STATE OF CONNECTICUT
CONNECTICUT SITING COUNCIL

IN RE: :
 :
APPLICATION OF CELLCO : DOCKET NO. 469
PARTNERSHIP D/B/A VERIZON :
WIRELESS FOR A CERTIFICATE OF :
ENVIRONMENTAL COMPATIBILITY AND :
PUBLIC NEED FOR THE CONSTRUCTION, :
MAINTENANCE AND OPERATION OF A :
WIRELESS TELECOMMUNICATIONS :
FACILITY AT 520 BAILEY HILL ROAD IN :
KILLINGLY, CONNECTICUT : SEPTEMBER 21, 2016

**RESPONSES OF CELLCO PARTNERSHIP D/B/A VERIZON WIRELESS
TO CONNECTICUT SITING COUNCIL PRE-HEARING QUESTIONS, SET ONE**

ALL-POINTS TECHNOLOGY CORPORATION

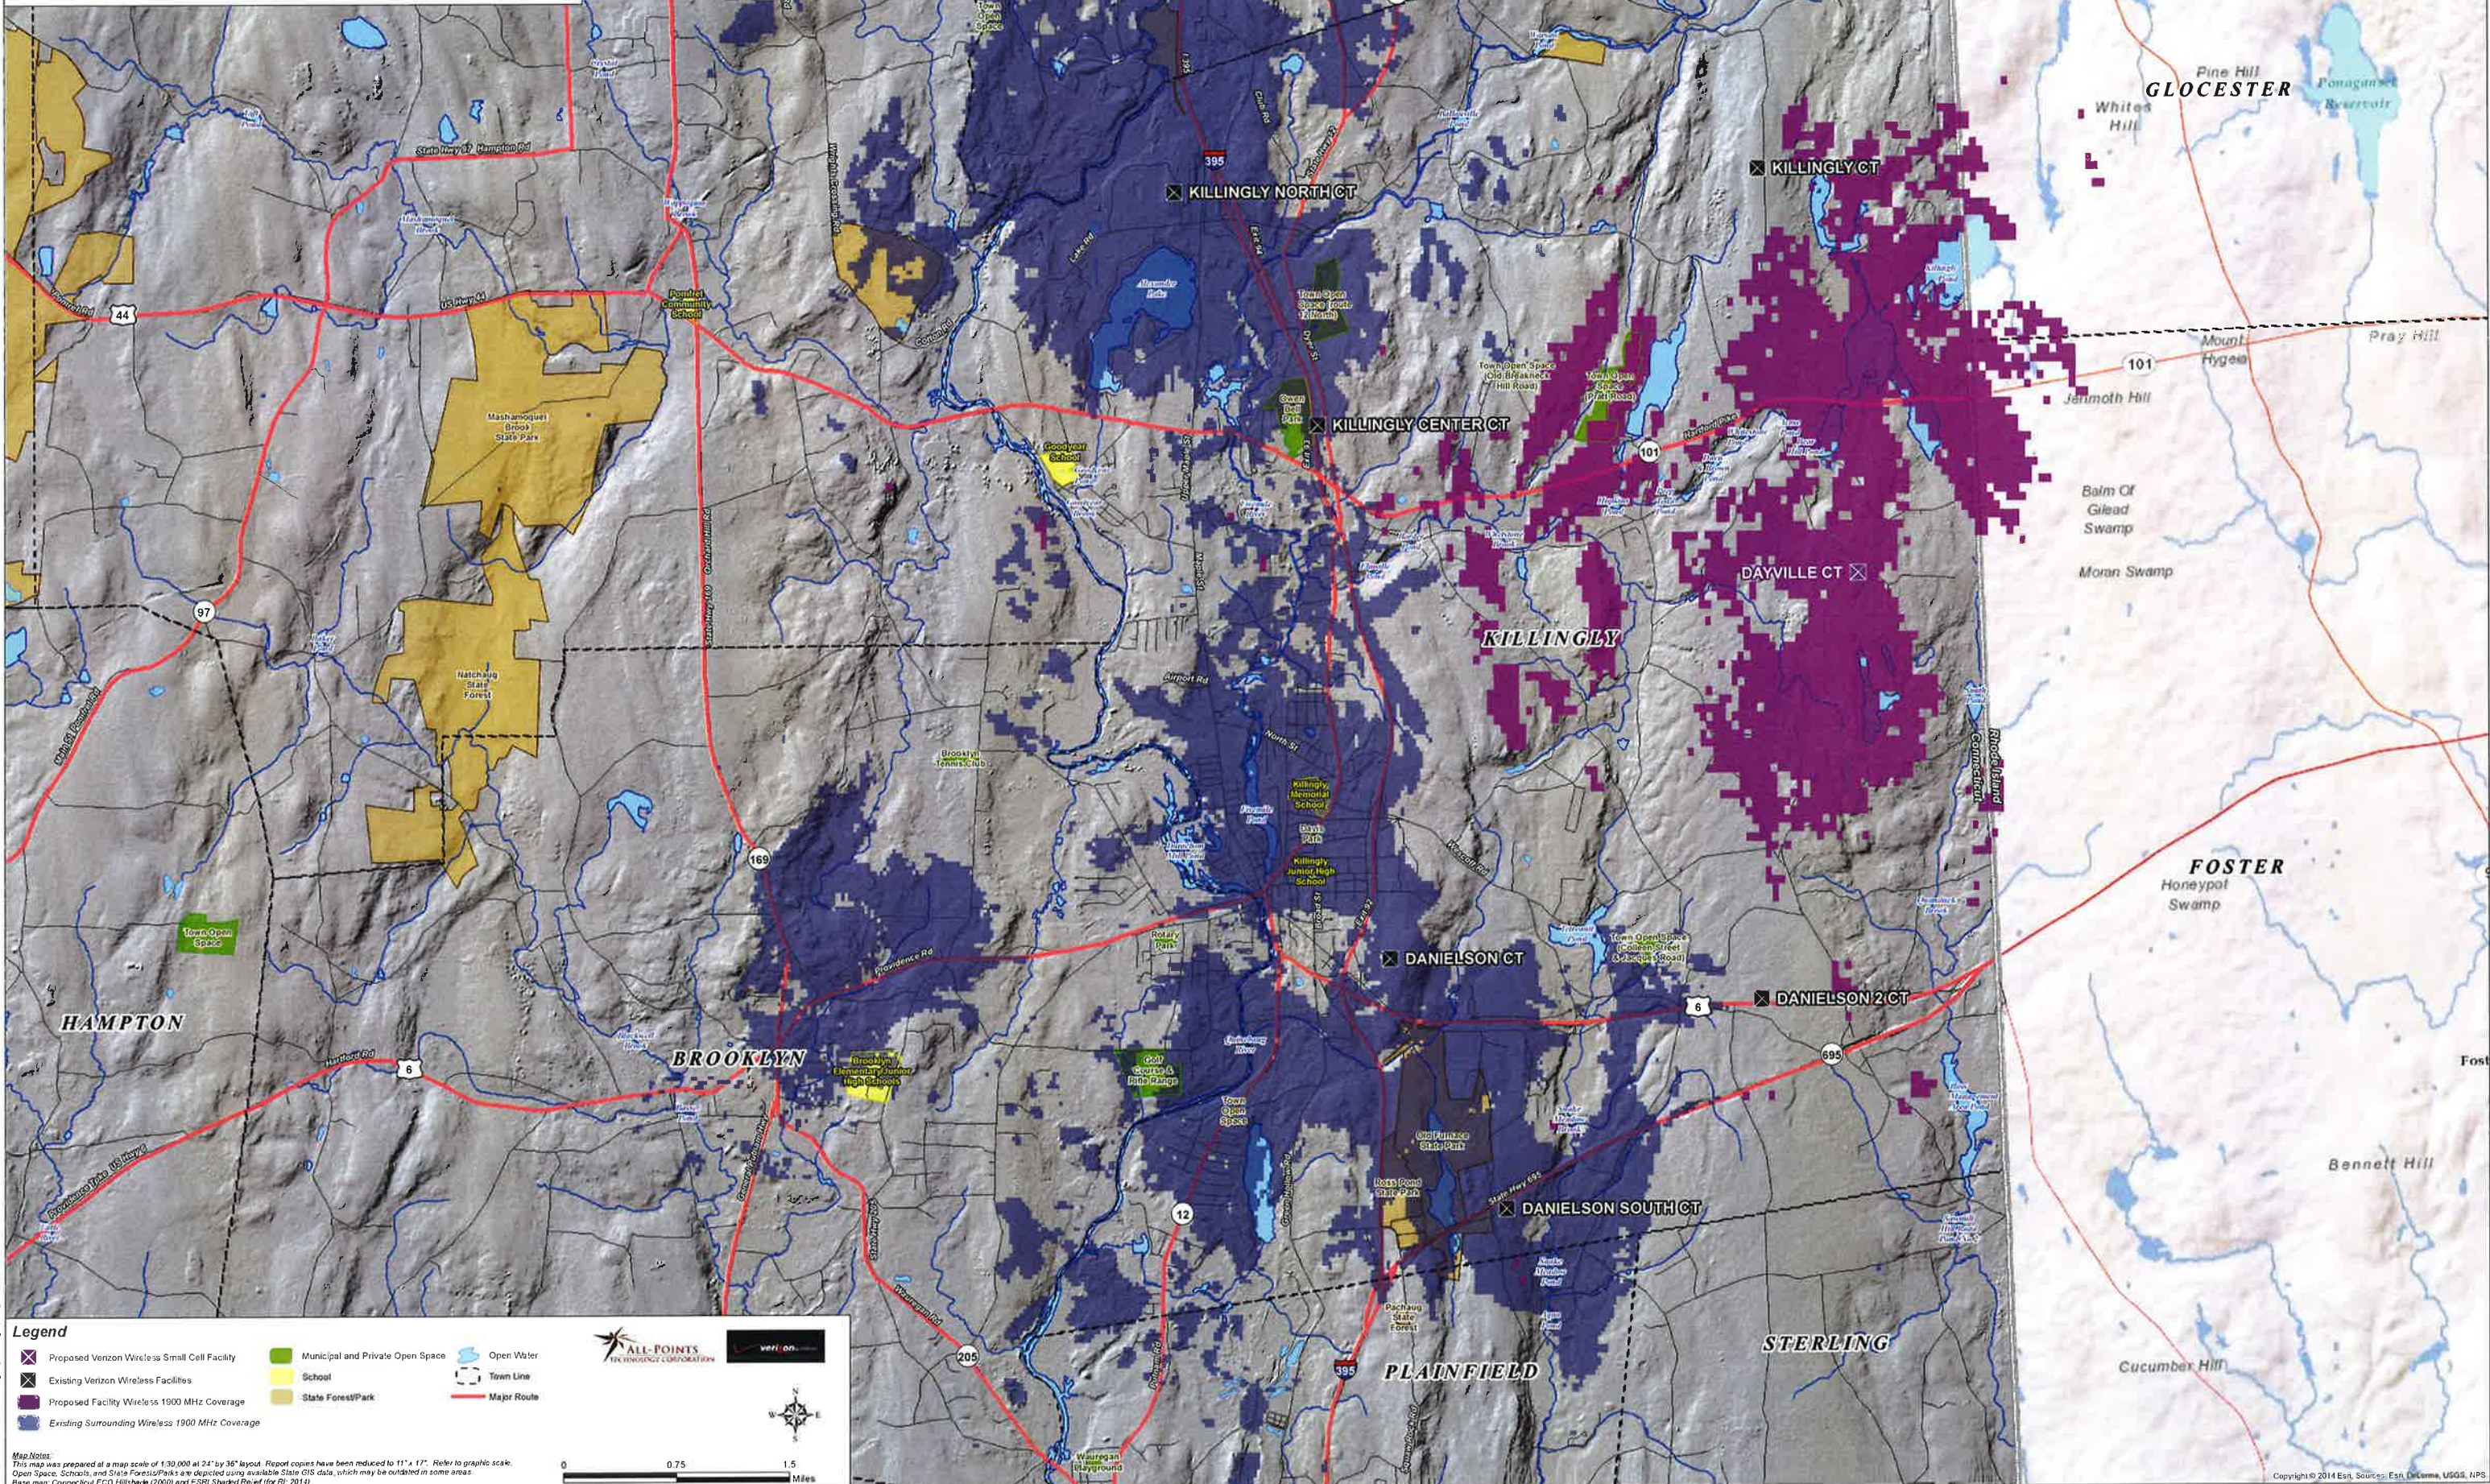
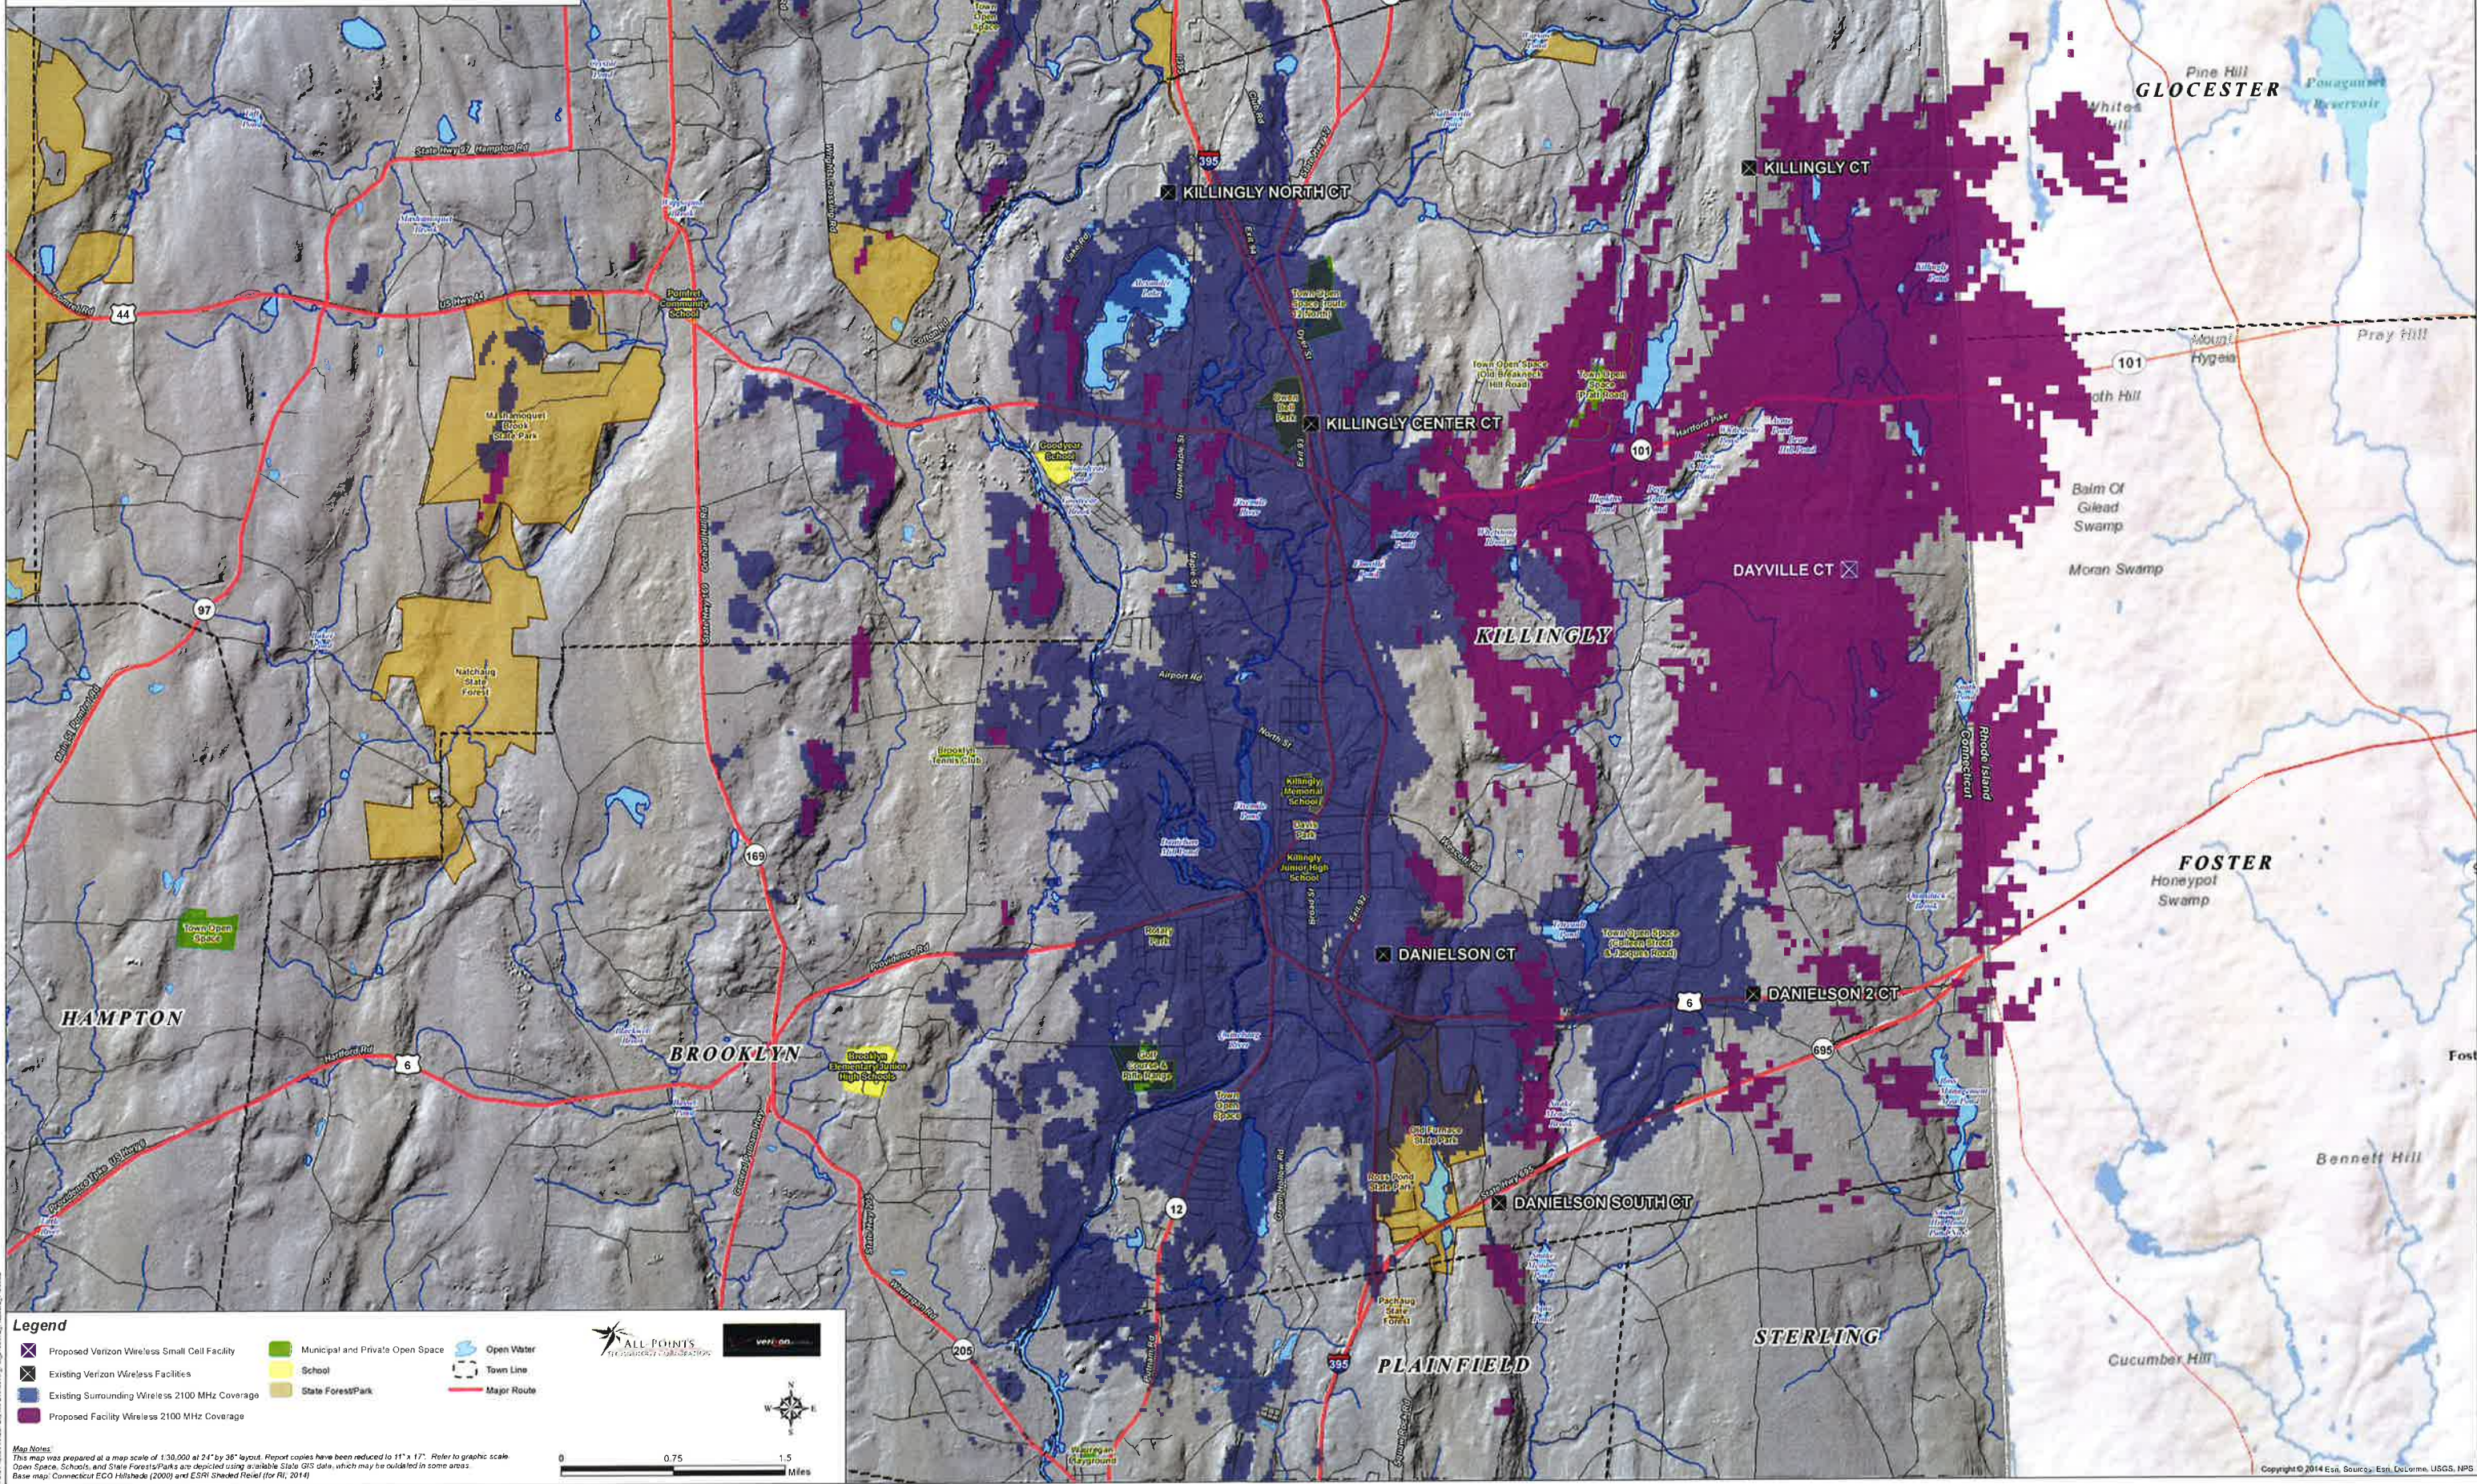
Similar to the proposed propagation maps, submit propagation maps for all four frequency bands (i.e. 700 MHz, 850 MHz, 1900 MHz, and 2100 MHz) assuming that the tower

is ten feet shorter than proposed (i.e. antennas are installed at a centerline height of 140 feet above ground level).

The propagation maps requested are included in Attachment 2.
